**LEVY NUCLEAR PLANT, UNITS 1 AND 2
DOCKET NOS. 52-029 AND 52-030
SUPPLEMENTAL RESPONSE TO NRC RAI LETTER 124 – SRP SECTION 6.3 AND NRC
RAI LETTER 116 – SRP SECTIONS 6.3 AND 15.2.6 TO ADDRESS CONTAINMENT
CONDENSATE RETURN COOLING DESIGN**

**Levy Nuclear Power Plant Units 1 and 2
Revised Response to Selected Questions from NRC Request for Additional
Information Letter No. 116 Related to SRP Sections 6.3 and 15.2.6 for the
Combined License Application, dated March 6, 2014**

NRC Letter No.: LNP-RAI-LTR-116

Figure 1: Original Analysis Approach

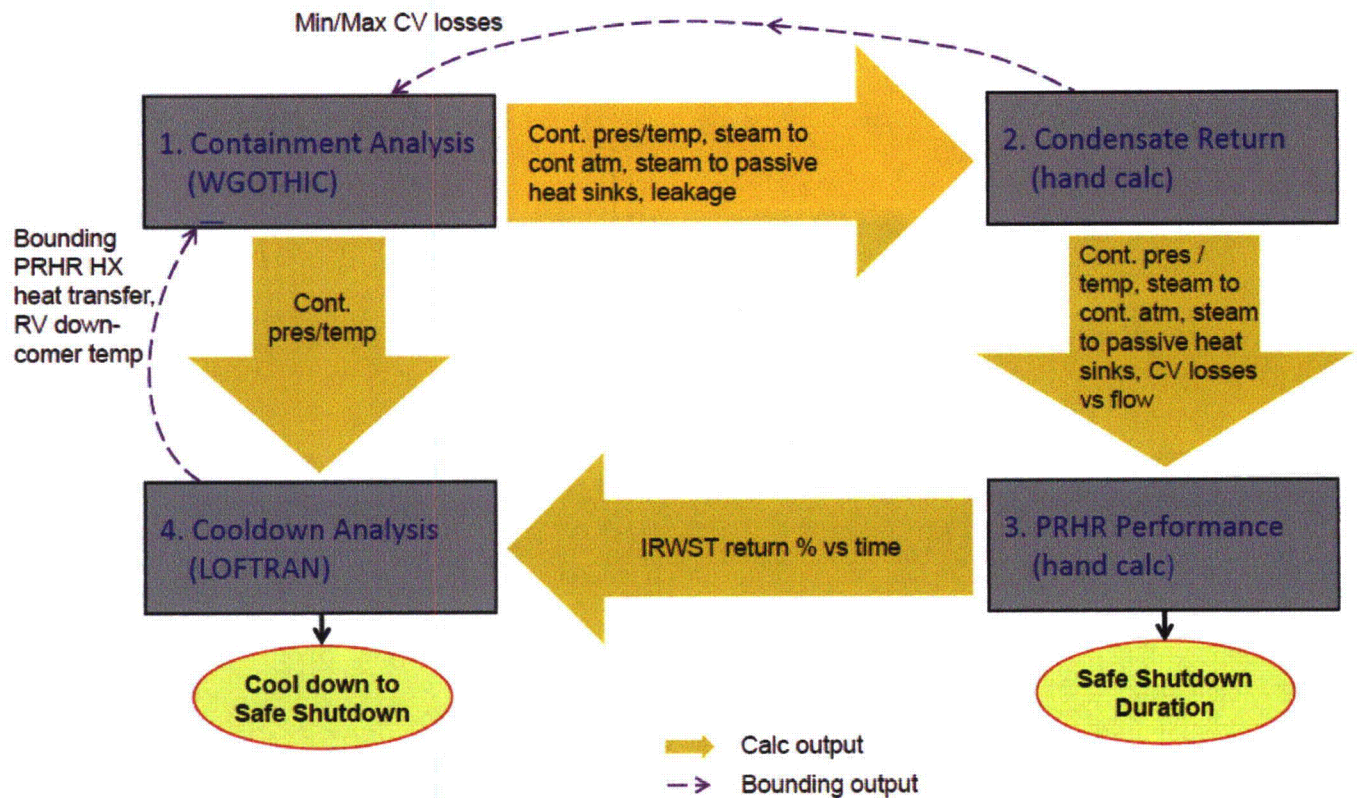
Figure 9 of the Levy submittal dated February 7, 2014, provides an illustration of inter-relationships of four calculations.

- a. Explain this figure describing how information flows from one calculation to the other for design basis and best estimate calculations.
- b. Explain how information flow loops are addressed. For example, APP-PXS-M3C-071 feeds containment pressure and temperature to SSAR-GSC-536, which feeds back bounding PRHR HX heat transfer and reactor vessel downcomer temperature to APP-PXS-M3C-071, creating a loop.

Figure 1 below shows the original interrelationship between the four calculations for the design basis and conservative, non-bounding analysis cases.

1. Containment Analysis

The purpose of "1. Containment Analysis" is to quantify the In-Containment Refueling Water Storage Tank (IRWST) water losses due to the mass of steam that is lost due to condensing on internal heat sinks, steam which pressurizes the atmosphere, and steam lost due to containment leakage.

"1. Containment Analysis" provides inputs into "2. Condensate Return". The main inputs include the containment pressure and temperature, mass of steam that condenses on heat sinks, mass of the steam that is in the containment atmosphere, and steam lost due to containment leakage. These values were solved by starting with WGOTHIC containment peak pressure model from revision 19 of the DCD and making changes to develop a conservative containment response to model condensation losses during Passive Residual Heat Removal (PRHR) Heat Exchanger (HX) operation.

"1. Containment Analysis" provides input into "4. Cooldown Analysis". The input provided to this calculation is the containment pressure and temperature response.

"1. Containment Analysis" evaluates two different fixed percentage losses from the CV, a minimum and a maximum which bound the actual loss which is determined in "2. Condensate Return".

"1. Containment Analysis" uses a bounding PRHR HX heat transfer rate and Reactor Vessel (RV) downcomer temperature input from the "4. Cooldown Analysis". The input from "4. Cooldown Analysis" provides a PRHR HX performance that is bounded on the high end to maximize the steam generated from the IRWST. The RV downcomer temperature is used to generate steam from the RV, which heats the lower portions of containment. The use of a bounding input avoids the need to iterate the calculations.

2. Condensate Return

The purpose of "2. Condensate Return" is to quantify the losses from the IRWST.

"2. Condensate Return" provides inputs into "3. PRHR Performance". The inputs provided into this calculation include the containment pressure and temperature, mass of steam to the containment atmosphere, mass of the steam to passive sinks and mass of steam lost due to containment leakage. These parameters are provided as a function of time. An additional input that is provided is a table of the losses from the CV shell (dripping, splashing) as a function of flow. The losses from the CV shell include rainout from the center of the dome and splashing losses due to CV plate weld misalignments, attachment plates, and losses at the entrance to the gutter.

"2. Condensate Return" uses the output results from "1. Containment Analysis" for the containment pressure and temperature, mass of steam to the containment atmosphere, mass of the steam to passive sinks and mass of steam lost due to containment leakage.

3. PRHR Performance

The purpose of "3. PRHR Performance" is to calculate the inputs necessary for "4. Cooldown Analysis", to demonstrate adequate safe shutdown duration and to evaluate potential Chapter 15 design basis analysis impacts.

"3. PRHR Performance" calculates the long-term transient performance including Reactor Coolant System (RCS) cooldown and re-heat (in the long term), IRWST heatup and boiloff due to PRHR HX input, PRHR HX performance based on RCS and IRWST temperature and level, and steaming from the RV. The inputs from "2. Condensate Return" are also used in this calculation. In addition to evaluating whether the Chapter 15 analyses would be affected, this calculation demonstrates that the safe shutdown duration is adequate.

"3. PRHR Performance" provides inputs into "4. Cooldown Analysis". The input provided into this calculation is the condensate return rate as a function of time. The time for the IRWST to reach saturation and the time for the top of the PRHR HX tube bundle to uncover are used for comparison purposes in "4. Cooldown Analysis."

"3. PRHR Performance" provides information to evaluate the potential impact to the Chapter 15 analyses. This information includes the time to uncover the top-most PRHR HX tubes and the

impact of PRHR HX tube uncover on RCS cooldown. Examination of the aforementioned information from "3. PRHR Performance" determined re-evaluation of the Chapter 15 analyses using the time-dependent condensate return rate would yield similar analysis results. Therefore re-evaluation of the Chapter 15 analyses was not required.

4. Cooldown Analysis

The purpose of "4. Cooldown Analysis" is to verify the PRHR HX can reduce the core average temperature to 420°F in 36 hours. The return rate as a function of time is input from "3. PRHR Performance" to account for all of the condensate losses once the IRWST begins to boil.

"4. Cooldown Analysis" also receives the containment pressure vs time from "1. Containment Analysis."

"4. Cooldown Analysis" also provides a bounding input to "1. Containment Analysis" for the PRHR HX heat transfer rate and RV downcomer temperature as discussed above. By using this bounding input the need to iterate the calculations is eliminated.

Design Basis Accidents (DBA) and **conservative, non-bounding** analyses are included as separate cases within these same calculations using the same approach. As a result, the flow of information between the calculations for both DBA and **conservative, non-bounding** cases remains the same as previously discussed.
